Informal Joint Working Group of GRB and GRRF – 26/27 May 2010

Comments on doc of ISO/TC31/WG6(?)
STD-03-06

Peculiarity of Doc STD-03-06 page 14.

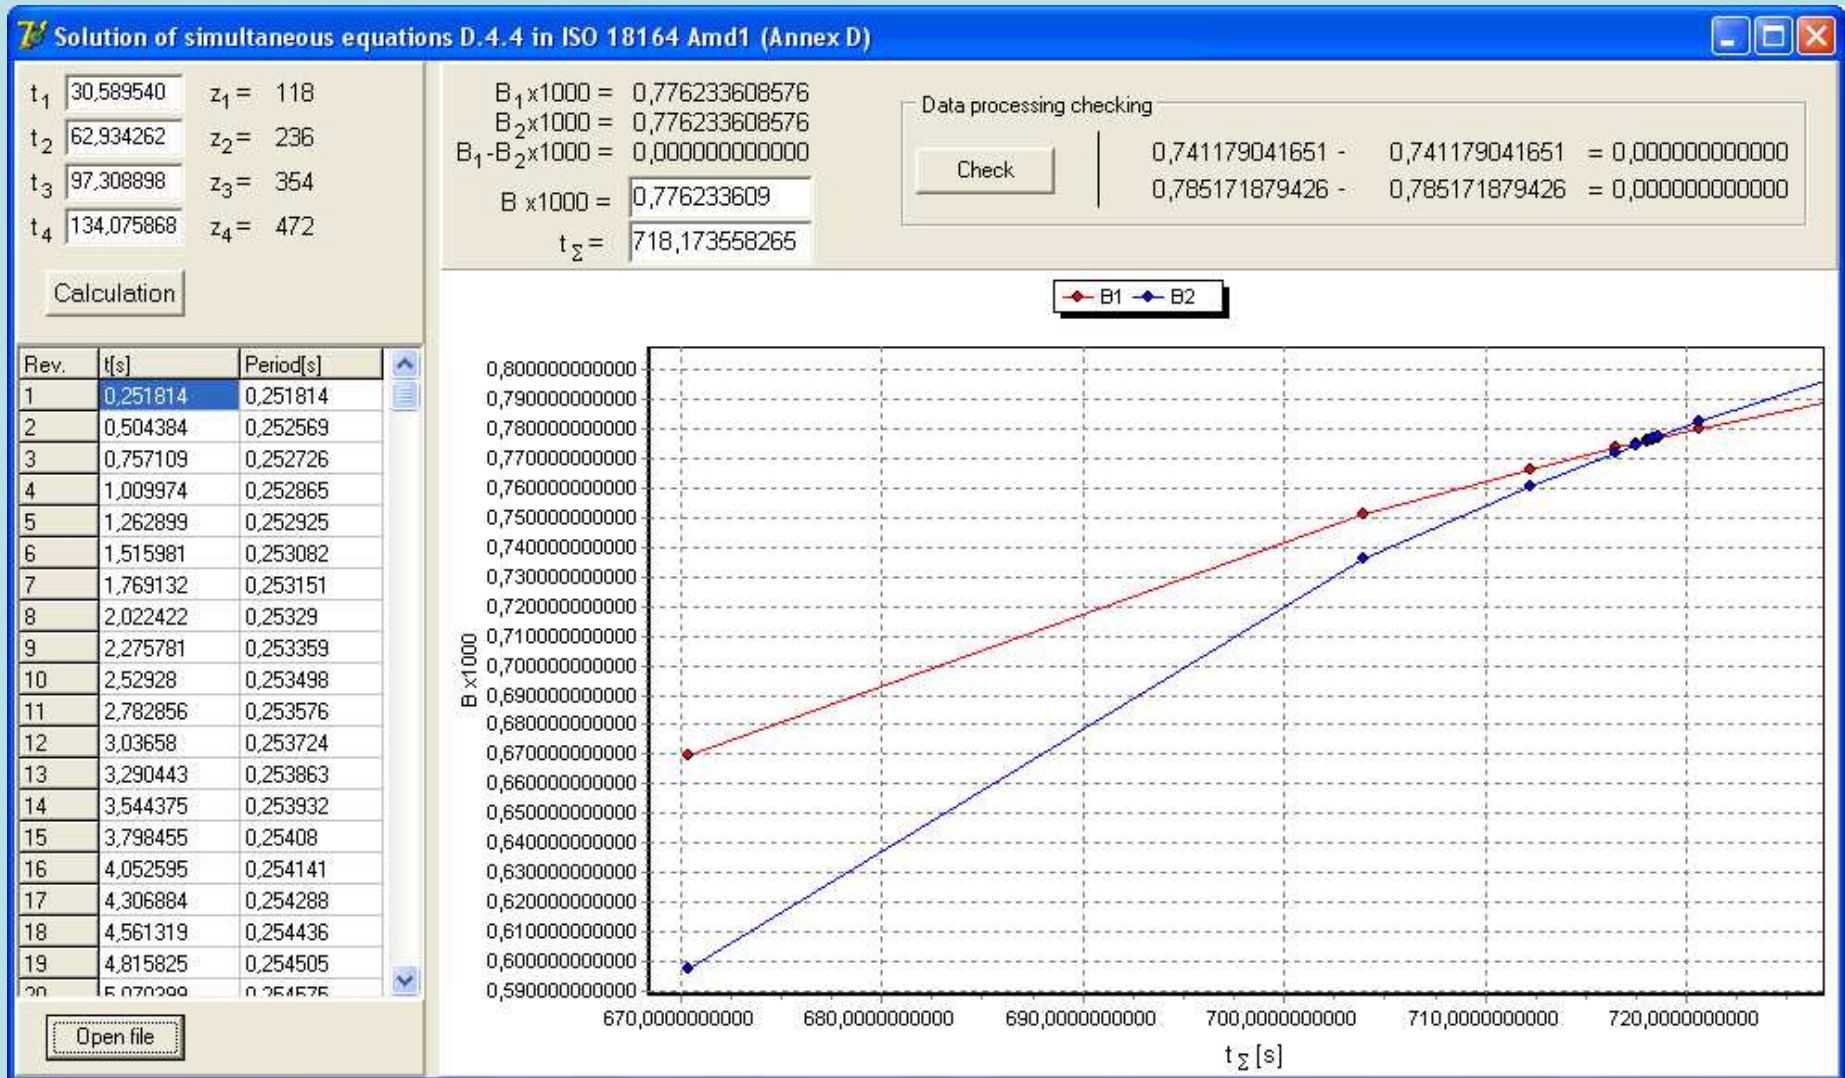
This page contains an affirmation that “time-distance” method gives periodical multivalued results.

As it well known correct solution of equation with periodic functions requires **to specify initial conditions or constraints** for finding realistic roots.

“Commonly accessible tool Microsoft Excel solver” used by *Author* does not execute this procedure instead of investigator. This caused “multiple solutions”.

Correct solution of simultaneous equation cited from ISO/FDIS 18164 Amd1 is based on the property of realistic roots $Bt_{\Sigma} < \pi/2$ and never been multivalued (see for example visualization of simultaneous equations solution by iterations on next page).
